From: Goodier, Melanie
Sent: Fri, 20 Feb 2026 14:53:01 +0000
To: Graham, Katja
Cc: Development
Subject:AVA/2026/0066 - Development including installation of photovoltaic panels and an air source heat pump at 15 St Ronans Avenue, Duffield (Our Ref. 26/07959/PL01)
Attachments: Proposed arrangement, Block & Site Plan_102, Rev.A.pdf

The attached 'Proposed Arrangement Drawing, Block and Site Plan' (102_Rev.A, Jan 2026) shows a proposed air source heat pump (ASHP) at the rear (south-east corner) of the application site (shaded red below):

Block & Location Plans

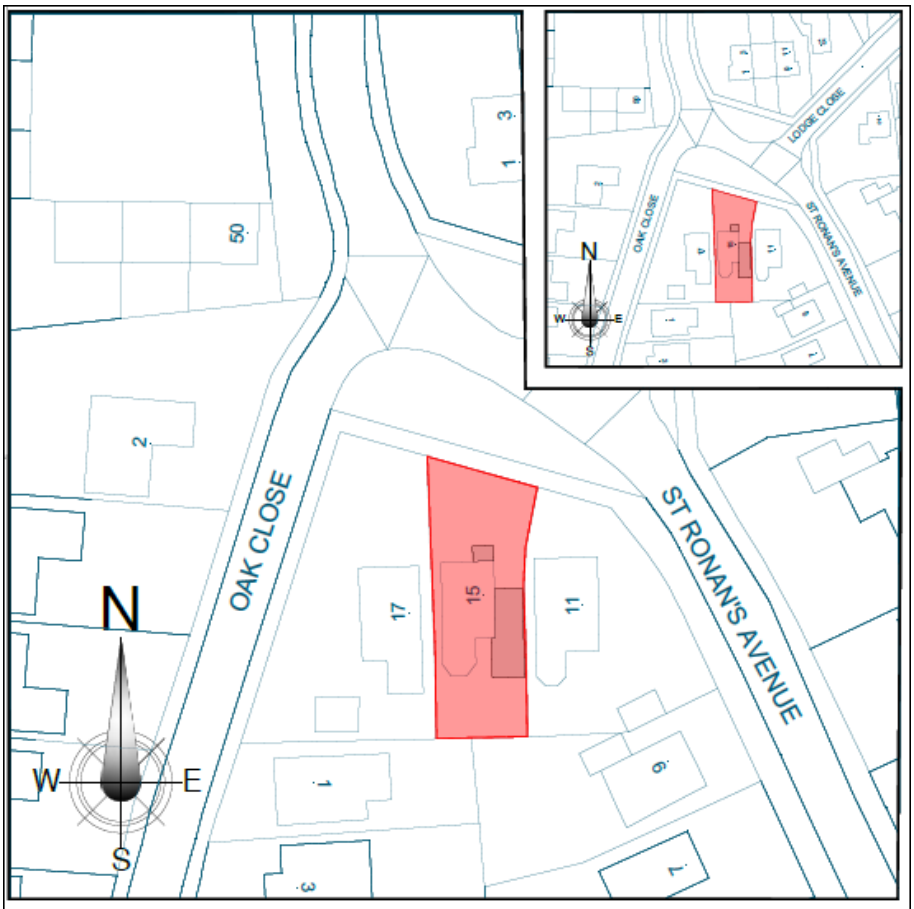
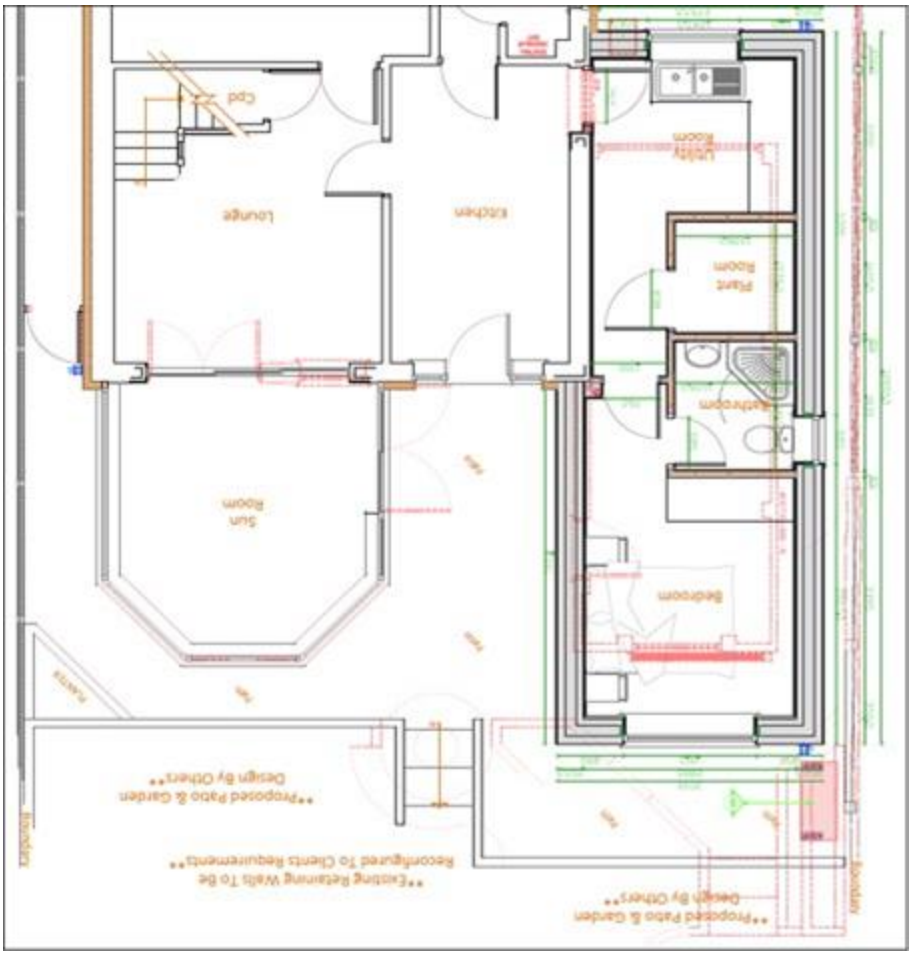
In the absence of a technical specification including noise emission data or an environmental noise assessment, I am unable to comment on the likely impact of noise emissions on noise-sensitive receptors in the vicinity of the application site. I would therefore advise that further information is provided before determination (for the reasons given above) or the following condition attached:

a) Prior to the installation of any air source heat pump, noise emissions shall be assessed in accordance with the guidance in 'Air Source Heat Pumps - Professional Advice Note' (Institute of Acoustics & Chartered Institute of Environmental Health, 02 February 2026), or subsequent revision. The pathway and compliance criteria (noise emission level) in all cycles/modes/operating conditions shall be identified and supported by an evidence-

based justification from a Suitably Qualified Acoustician (SQA) and agreed by the Local Planning Authority and Environmental Health Practitioner.

b) Where noise mitigation measures are required to achieve the agreed compliance criteria, a scheme shall be submitted to, and approved by, the Local Planning Authority. The approved scheme shall be implemented and maintained thereafter.

c) The air source heat pump(s) shall be fitted with vibration isolation mounts and pipe connections, as necessary, to prevent structure-borne transmission via walls and floors.

d) If the Local Planning Authority considers it necessary and justifiable, an assessment of noise emissions in-situ shall be submitted to confirm that the compliance criteria agreed prior to installation have been achieved.
